Precinct Village and Car Park

Value Management package

Minutes of Sydney Football Stadium Design Integrity Panel Presentation

Minutes of the Precinct Village and Car Park VM Design Presentation held on Monday 6 December 2021 via Microsoft Teams.

Tennis building

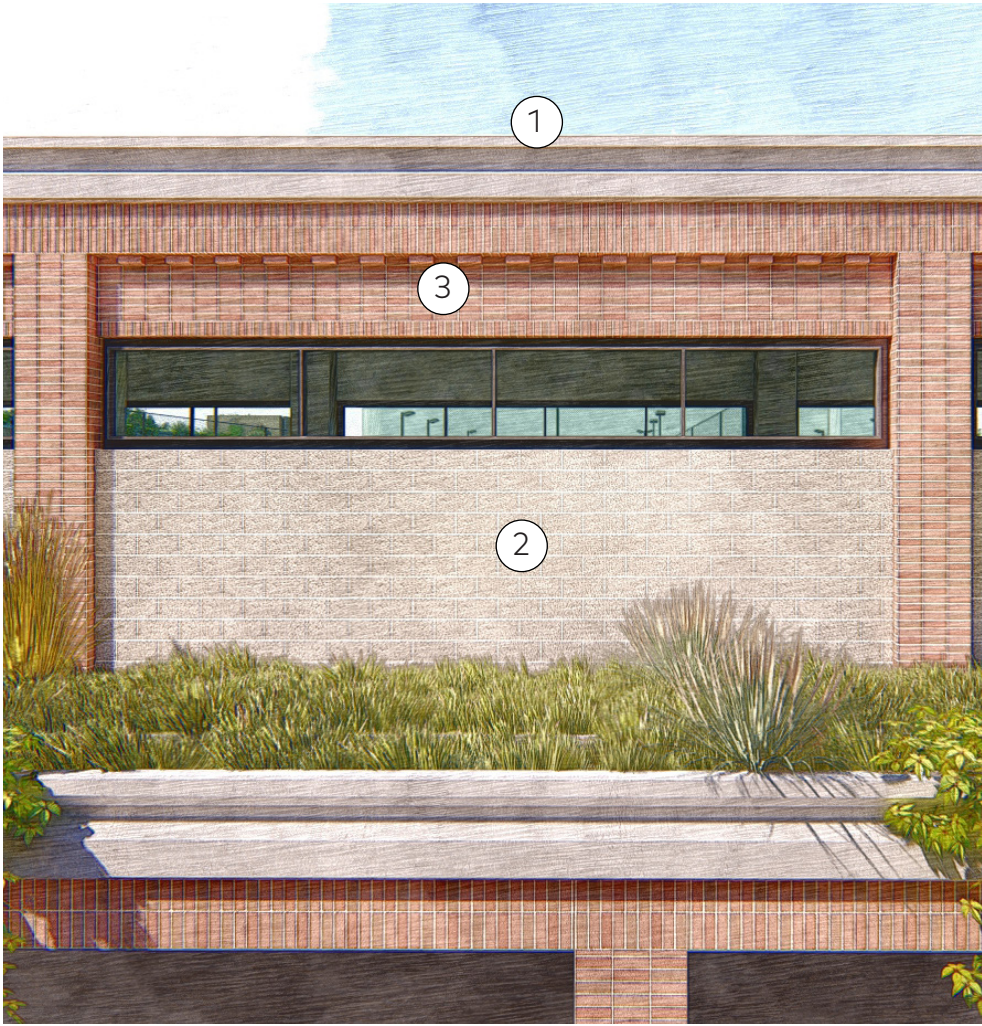
- 1 - Green edge to roof
- 2 - Brick wall between columns
- 3 - Stepping brick clad fascia

- 1 - Green edge on roof replaced by pebbles in a artistic pattern
- 2- Infill brick wall replaced by polished blockwork
- 3 - Brick clad fascia inspired by SCG perimeter brick wall

- AY provided an overview of the proposed option for the tennis club building which changes the stepping in the brick clad fascia replaces the brick wall between columns to polished blockwork consistent with material used in the stadium, and removes the green planted edge roof replacing it with pebbles in an artistic pattern.

- PP queried if the PV array will be on top of the tennis club roof. AY confirmed the roof is circa 500sqm and 200sqm is expected to be covered by PV panels. The balance of the roof could be covered by a public artwork in the option. PP further queried who will be able to see the pebble artwork. AY confirmed NRL building and Stadium users would be able to see the pebble artwork. PP queried if the roof finishes need to have a design or if it can be left without a design noting the extent of the PVs.

- KC further queried the cost savings for replacing the green roof with pebble artwork. MM confirmed cost savings are not the primary driver as VNSW is concerned with ongoing maintenance obligations and costs.

- KC queried if there are awnings proposed in the option for the tennis club as rain protection. AY confirmed that no overhang has been included in the option. KC confirmed no concerns with the changes to brickwork to the tennis club building. KC requested the design team review the need to provision for inclusion of fabric or other awnings at a later date.

- KC agreed and further noted that the hit and miss brickwork is not really fit for purpose so the team need to look at a more sophisticated landscape with the proposed option. Further that provisioning for installation of fabric awnings should be investigated to be added to the tennis club building if it will provide weather protection, simplification of the roof planting with PVs is supported.

- PP noted the rationale for removal of the “hit & miss” brickwork and its replacement with an integrated guard rail with landscape, agreed with KC regarding looking at fabric or other awnings to the tennis club building. Noted that the removal of design to roof planters would be acceptable subject to design team reviewing aspects from Stadium and NRL buildings.
